International Aero Engines SERVICE BULLETIN

ENGINE - HP TURBINE ROTOR AND STATOR ASSEMBLY - PROVIDE A NEW ORIFICE PLATE WITH
AN INCREASED OPENING SIZE

V2500-ENG-72-0236

Aug. 15/96

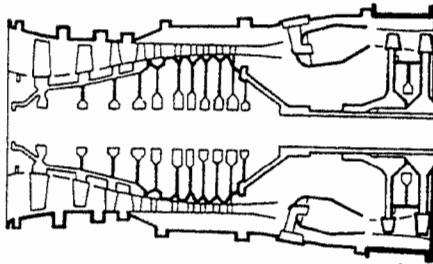
- (a) Set-up and machine to open the 0.835-0.845 in. (21,21-21,46 mm) diameter to 0.870 - 0.880 in. (22,10 - 22,35 mm) diameter.

- 1 Hold concentric to the outside diameter 0.010 in. (0.254 mm).

- 2 Break sharp edges 0.003 - 0.015 inch (0,08-0,38 mm).

Location of the Orifice Plate
Figure 1

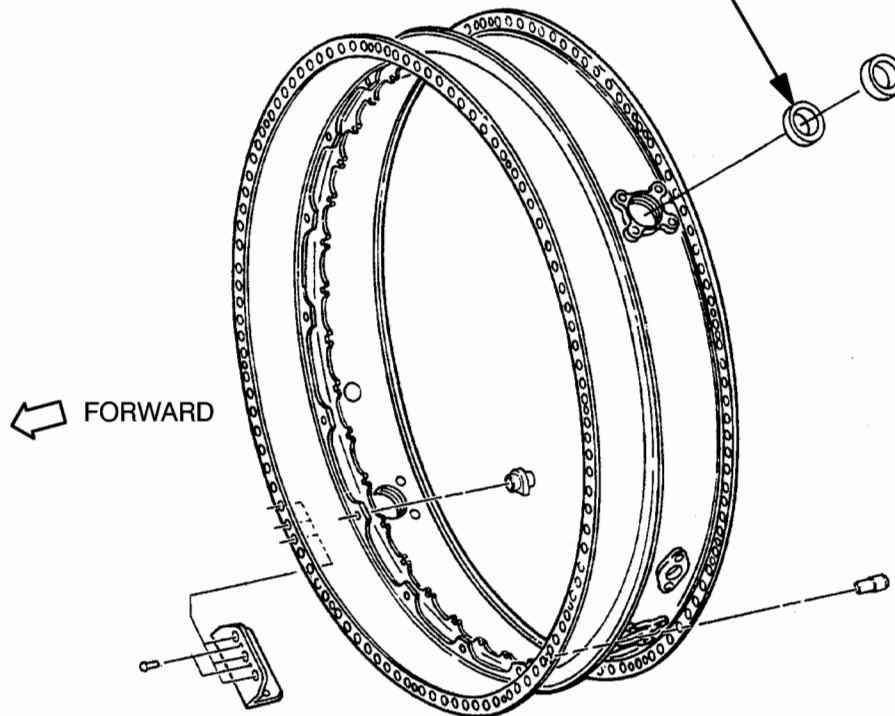
REPLACE THE 2A3692 ORIFICE PLATE
WITH THE 2A3734* ORIFICE PLATE (4 off)

NOTE: The new part can be obtained by
modification
